## Maintenance newsletter

here are some changes in basic maintenance to protect problems with broken studs.

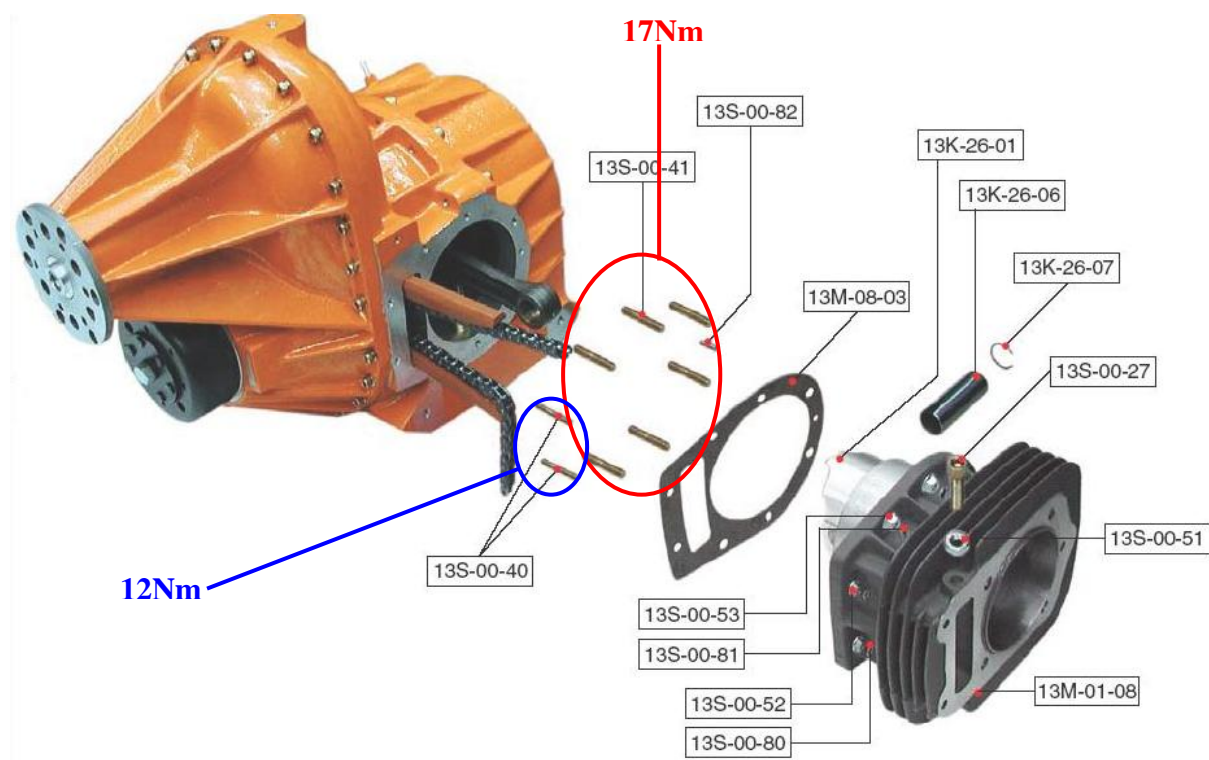
stud bolts M8x25 (13S-00-41) must be torqued to 17Nm

stud bolts M6x25 (13S-00-40) must be torqued to 12Nm

Studs must be checked after each 25 hours.
